DURHAM COUNTY

I-40 and Miami Blvd.

Date: April 4, 2017	County: Durham
Interchange: I-40 and Miami Blvd.	
Location (exit ramp): EB Exit Ramp

US 1 SB Exit Ramp at NC 55

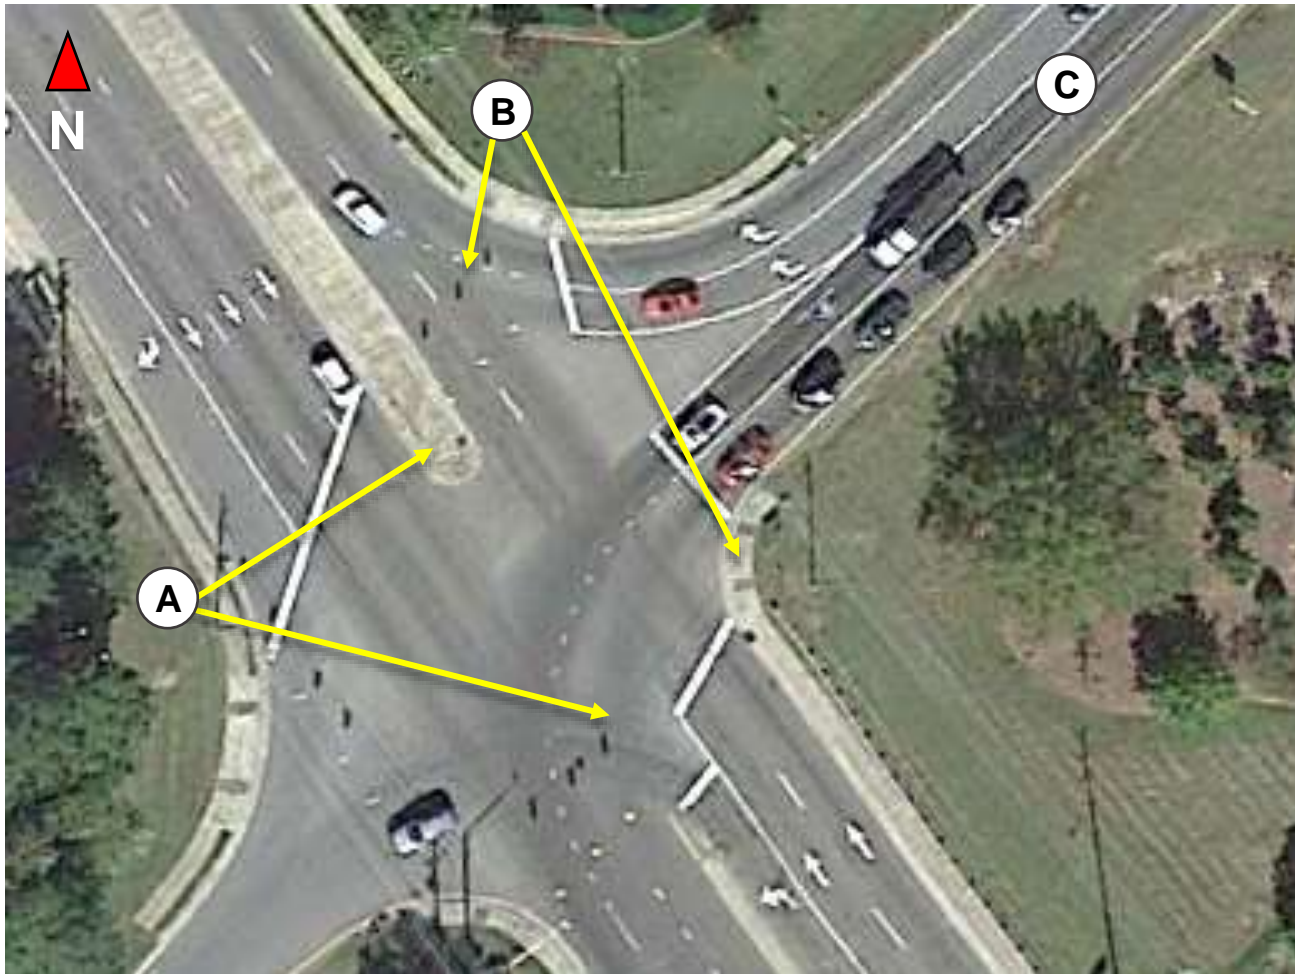
- A. Add No Left Turn Signs (on median and overhead span wire)
- B. Add No Right Turn signs (on corner and overhead span wire)
- C. Add Wrong Way arrows

US 1 NB Exit Ramp at Ten Ten Rd.

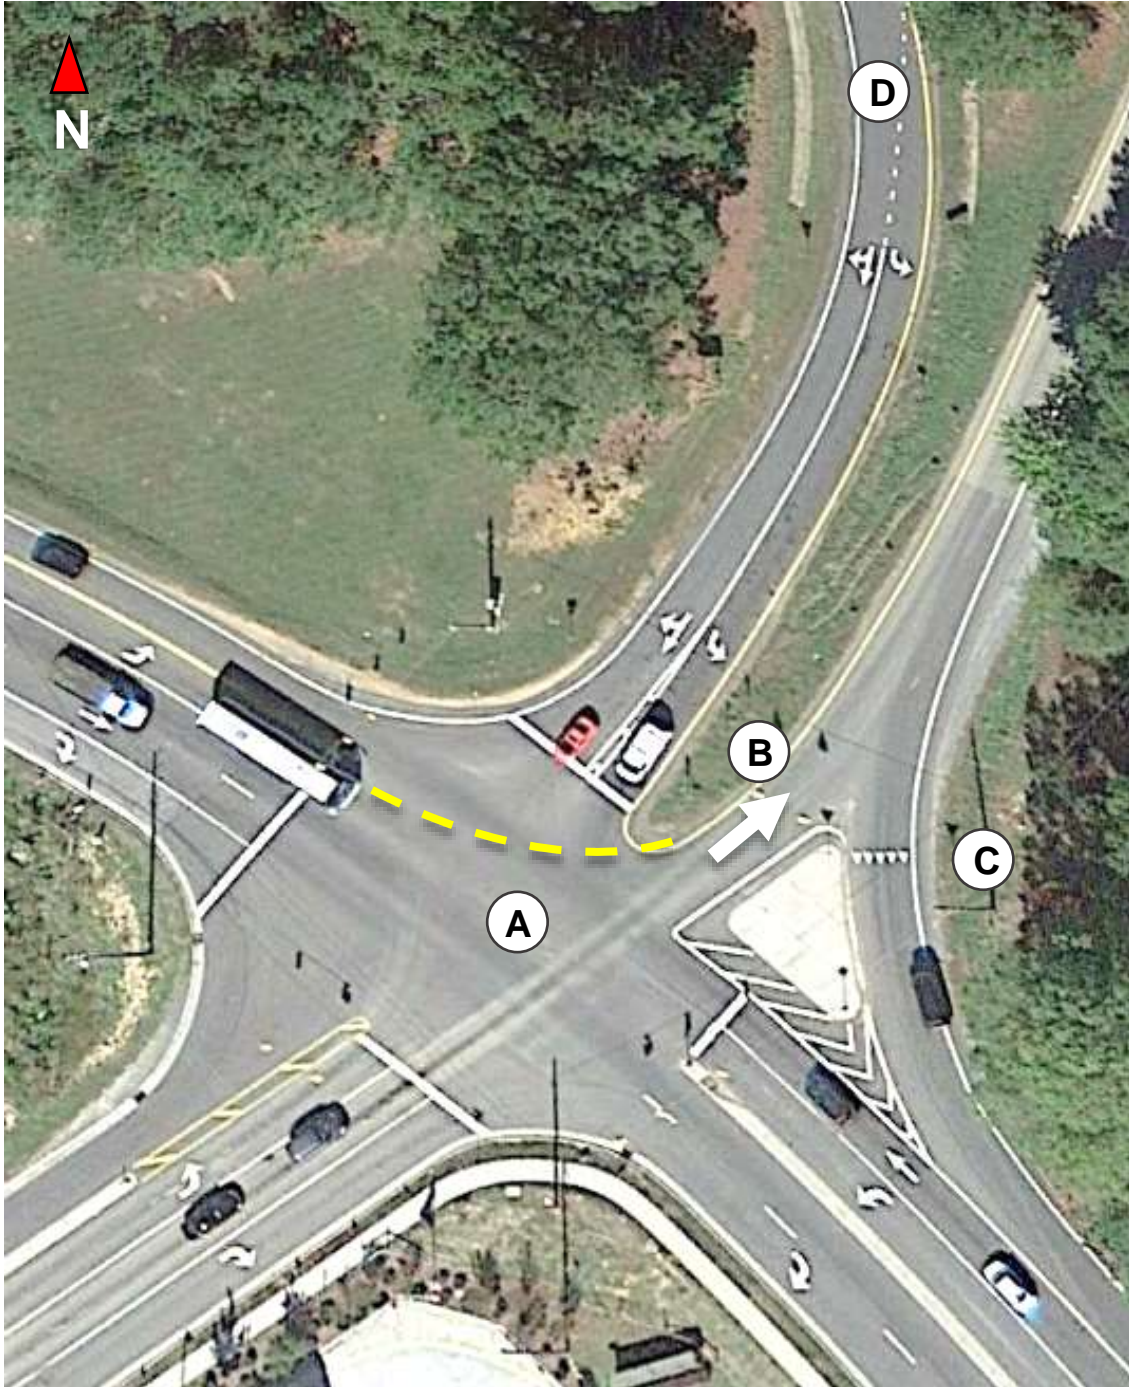
There is a horizontal curve on Ten Ten Rd at the location of this ramp terminal, which increases the confusion and complication of the intersection, especially at night. The potential wrong-way right turn onto the ramp is well-signed, the wrong-way left turn is problematic. Adding a streetlight on the entrance side of the ramp would highlight the appropriate entrance point.

- A. Add dotted lane line extension through intersection
- B. Add arrow indicating correct freeway entrance point
- C. Add streetlight to highlight appropriate entrance
- D. Add Wrong Way arrows

US 1 SB Exit Ramp at Ten Ten Rd.

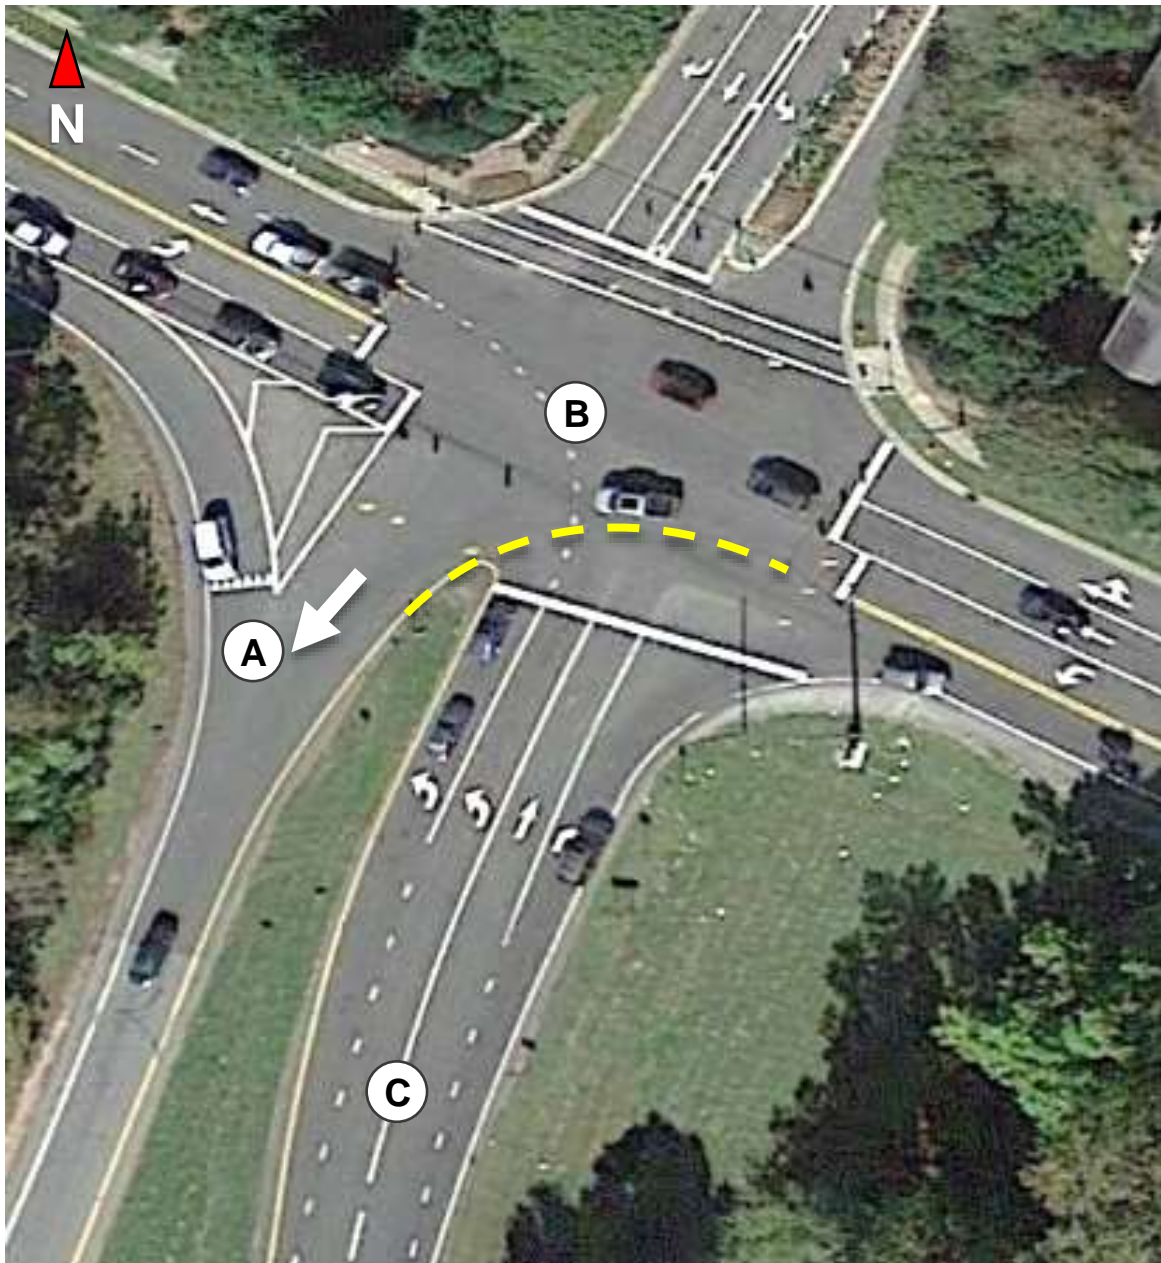
- A. Add dotted lane line extension through intersection**
- B. Add arrow indicating correct freeway entrance point**
- C. Add Wrong Way arrows**
